REMARKS

ANNOTATED SHEET SHOWING CHANGES

**FIG. 1****FIG. 2**

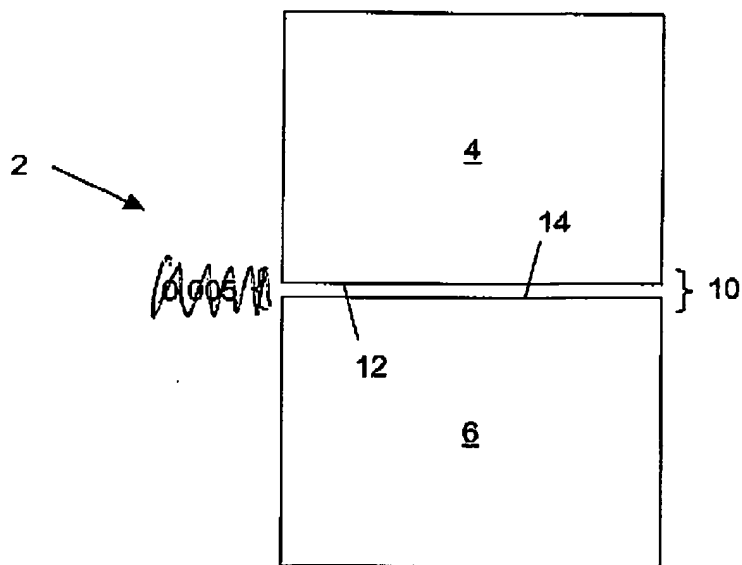
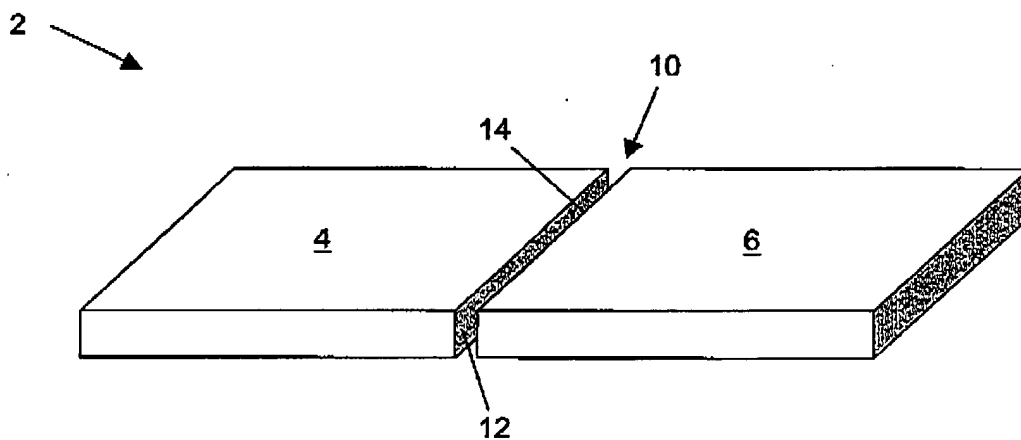
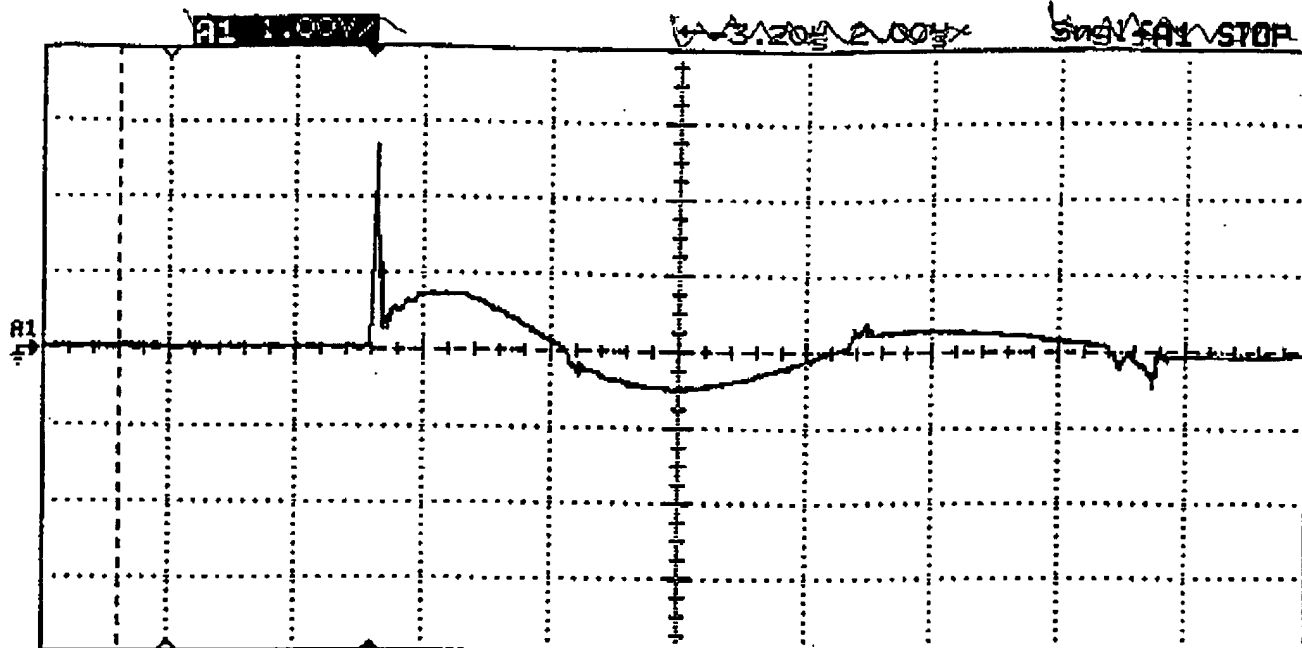
By the present amendment, replacement drawing sheets comprising Figs. 1, 3 and 4 have been submitted. In Fig. 1, the designation ".005" has been removed. In Fig. 3, the data sets regarding monitor settings and the designation "Plot 1" have been removed. In Fig. 4, the legend with symbols, the associated symbols, and the designation "Diagram 1" have been removed. Reference numbers 30 and 32 have been added to identify the air gaps. The specification has been amended to remove references to the designation ".005" being shown in Fig. 1, and to identify the reference numerals 30 and 32 added to Fig. 4. In view of the foregoing, it is believed that the drawing objections have been overcome.
